WOLF CREEK NUCLEAR OPERATING CORPORATION

ET 10-0005

Subject: Docket No. 50-482: Response to Request for Additional Information Related to License Amendment Request for Deviation from Fire Protection Program Requirements

REQUEST FOR ADDITIONAL INFORMATION
DEVIATION FROM FIRE PROTECTION PROGRAM REQUIREMENTS
WOLF CREEK NUCLEAR OPERATING CORPORATION
WOLF CREEK GENERATING STATION
DOCKET NO. 50-482

Attachment D

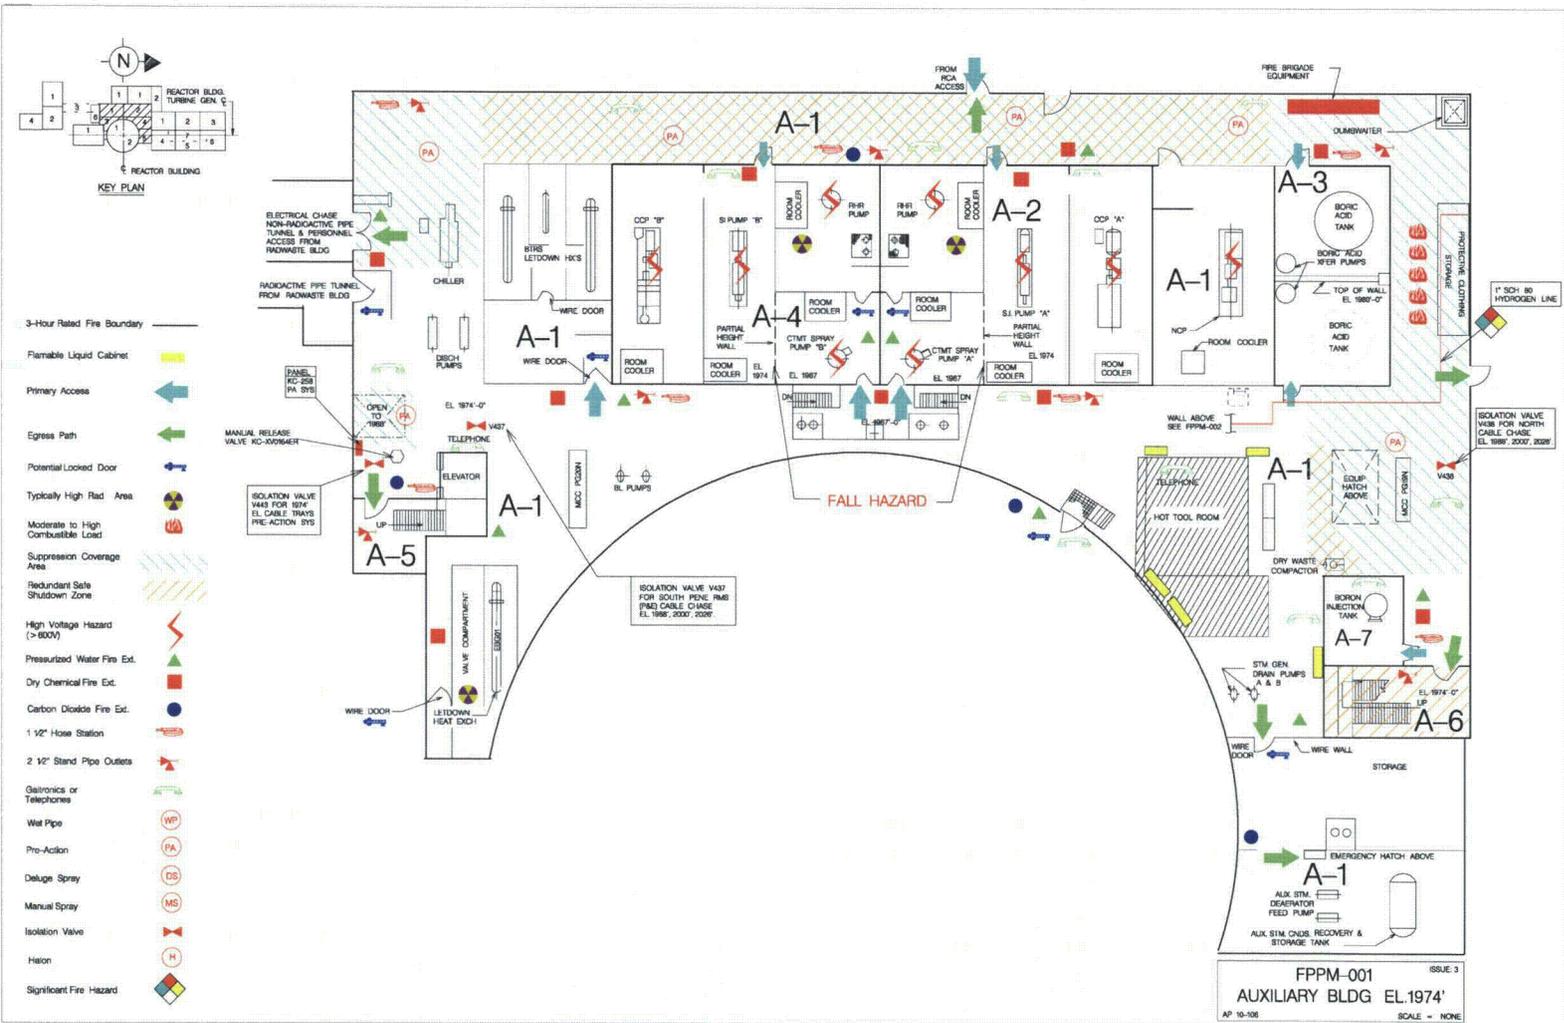
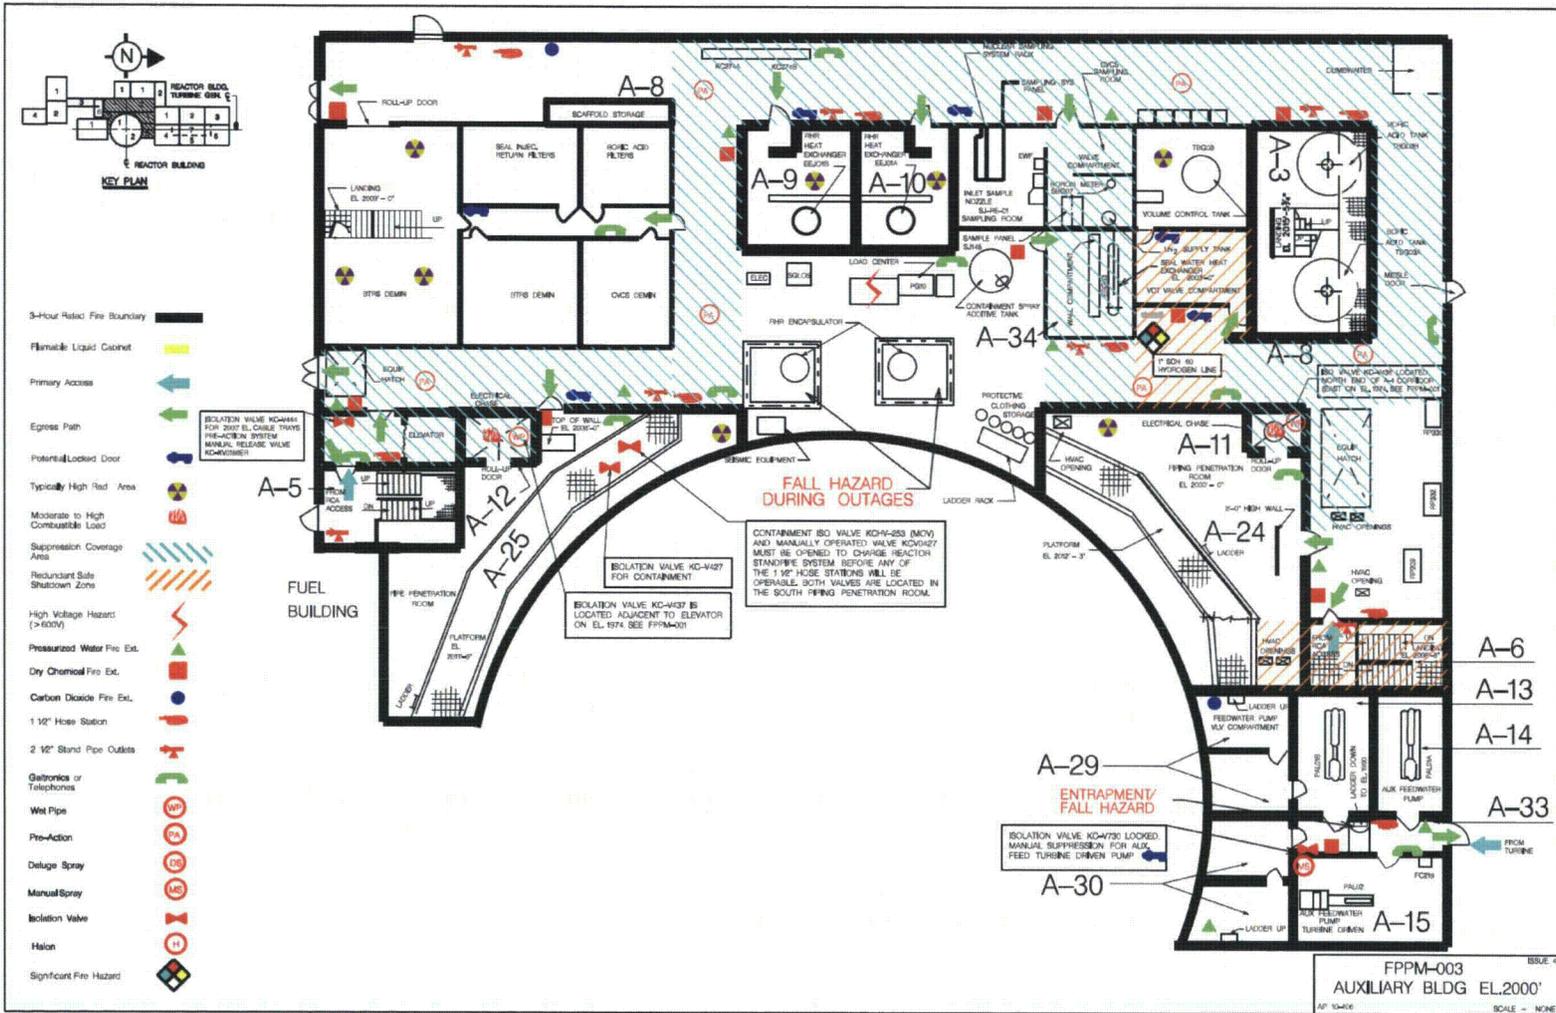
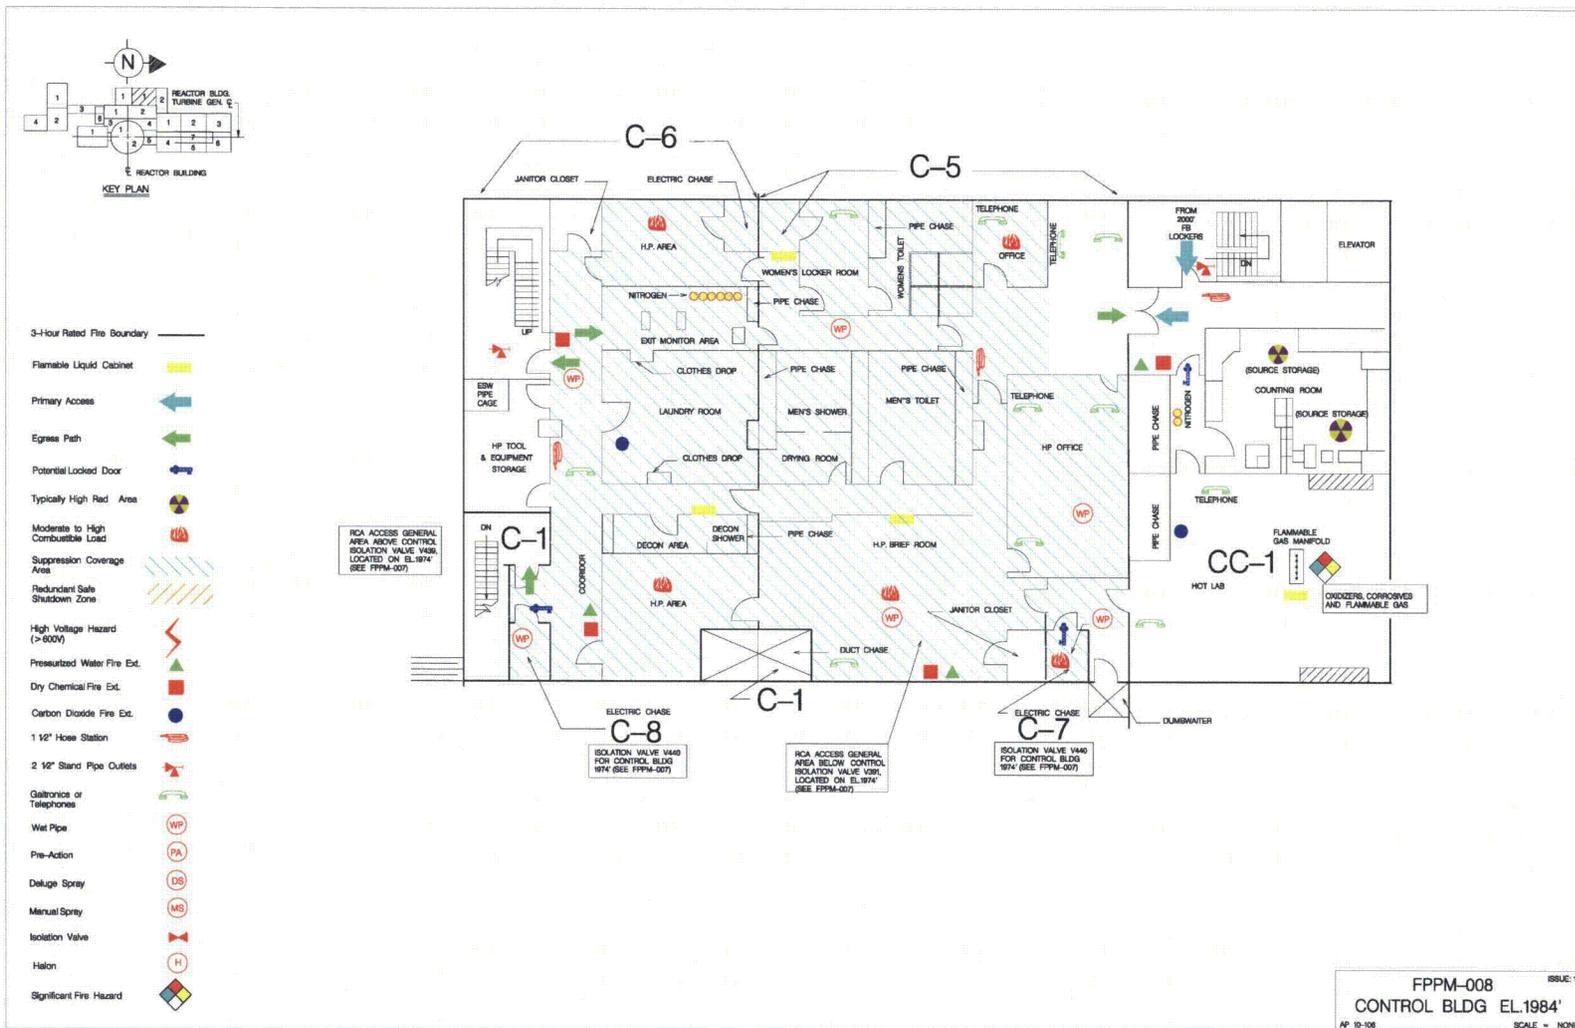
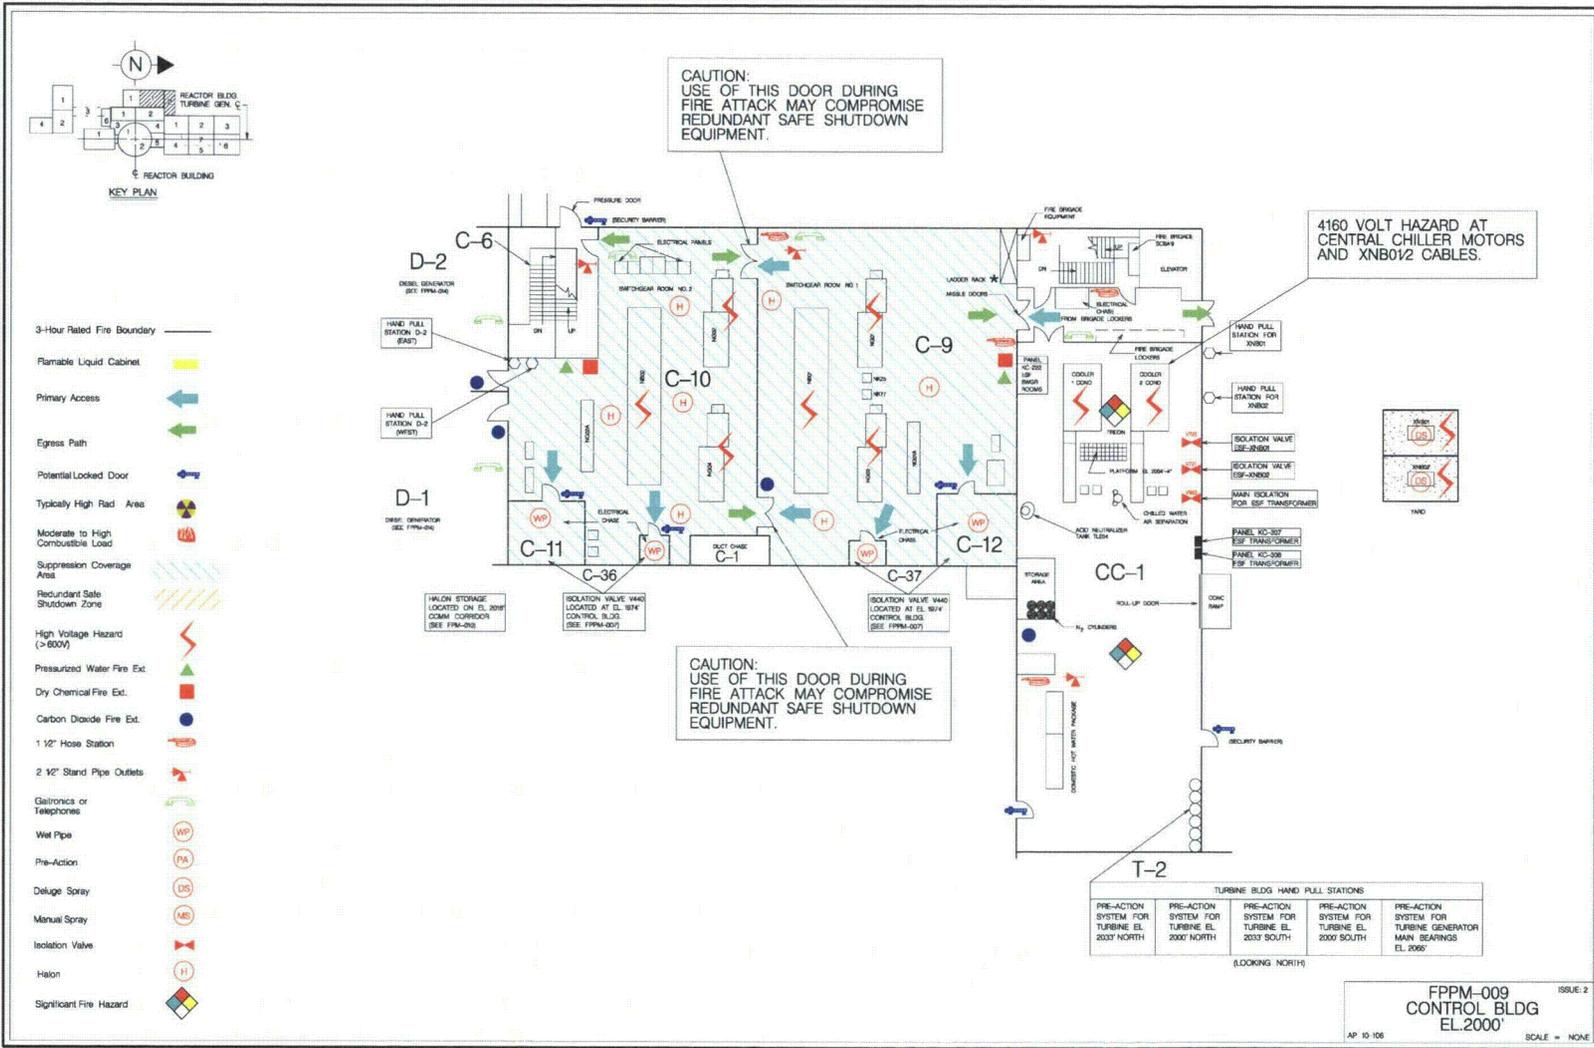
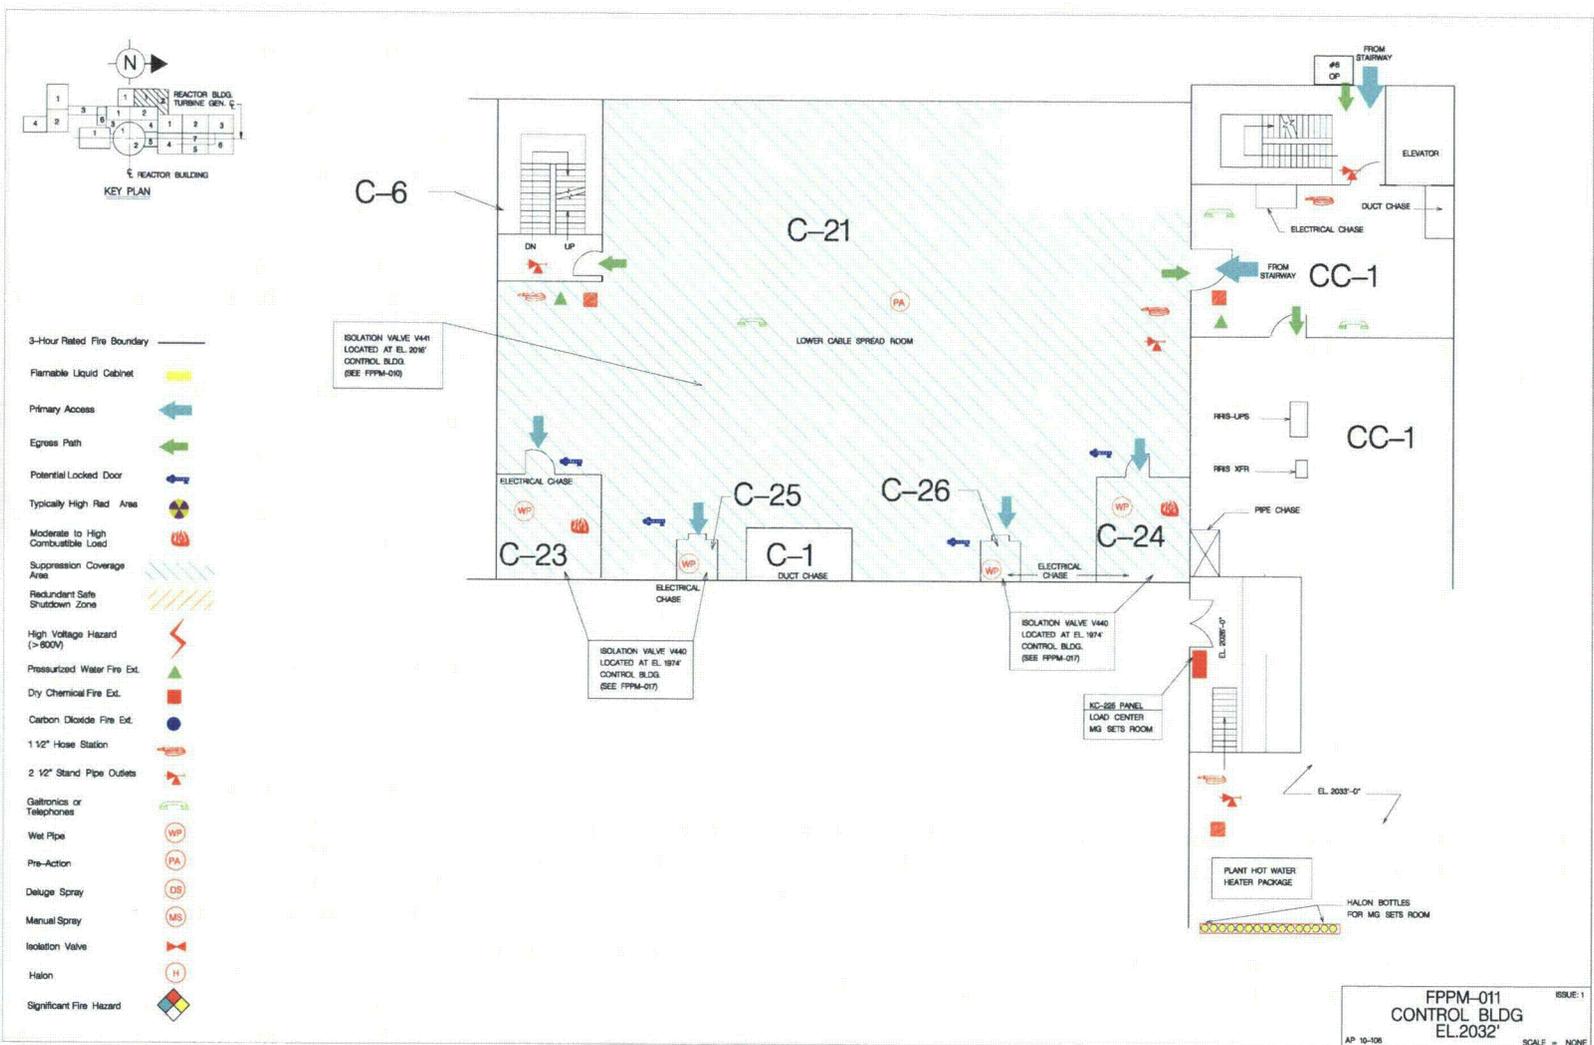
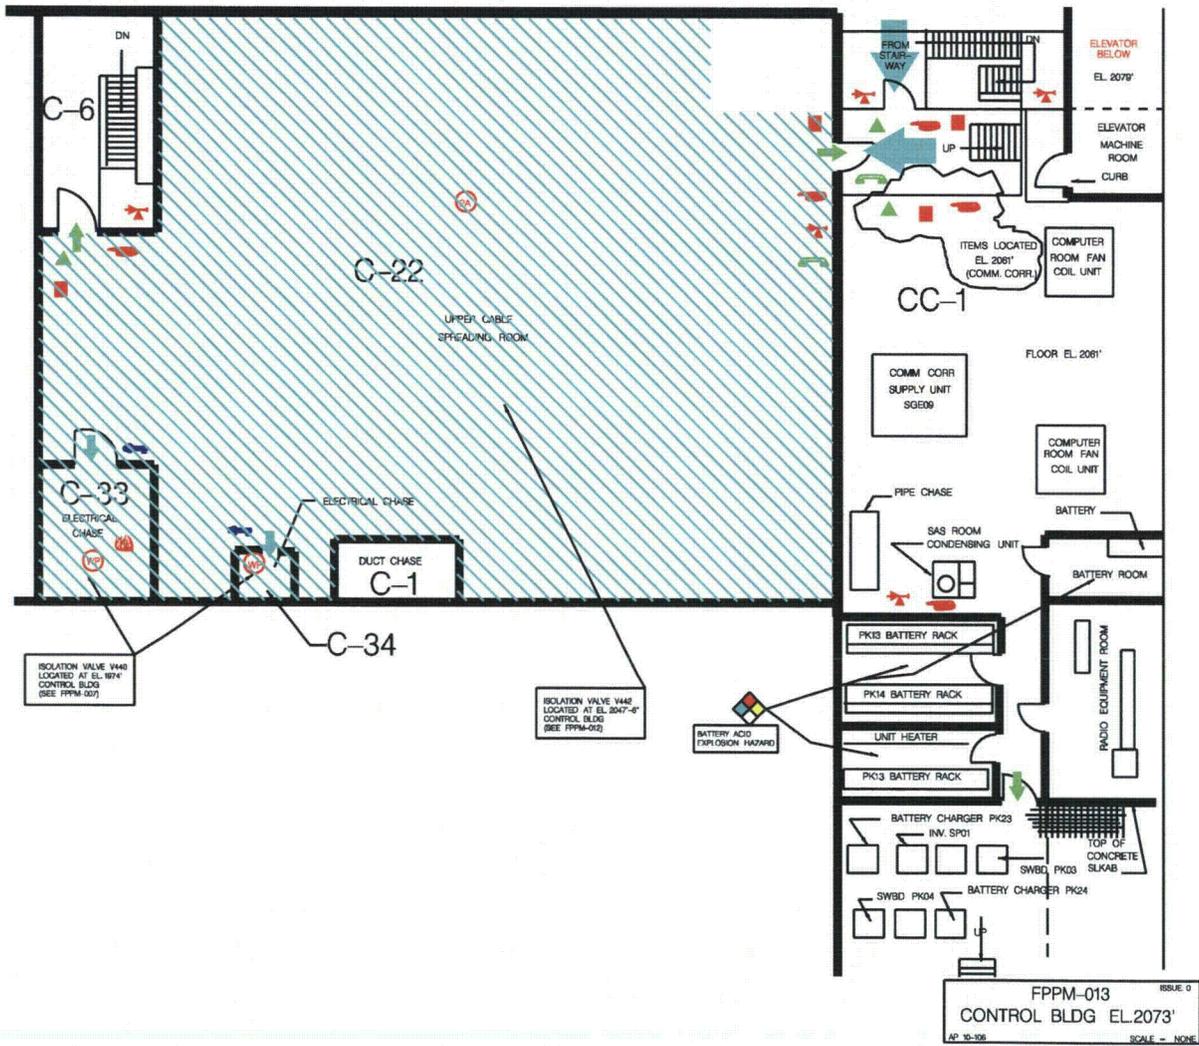
RAI-04.1: Please provide critical details or assumptions regarding the *in-situ* and transient fire hazards that could threaten redundant equipment for each fire area included in the requests. This information may include, but is not limited to:

RAI-05.1: Please provide a description of the proximity of the redundant train equipment to in-situ hazards and the spatial relationship between the redundant trains in the fire area such that if they are damaged, manual actions would be necessary. Note, that this question is distinct from the RAI addressing Ignition Sources and Combustible Loading, which is generally focused on the combustibles in an area, whereas this RAI addresses the specific relationship between ignition sources and combustibles and the redundant trains.

Section 8.X.1 of WIP-E-1F9900-004-A-1 was revised for each fire area to identify approximate room dimensions. Room height is also identified in Attachment B1 of WIP-E-1F9900-004-A-1. Attachment D was added to WIP-E-1F9900-004-A-1, to provide a general plan view for each fire area.
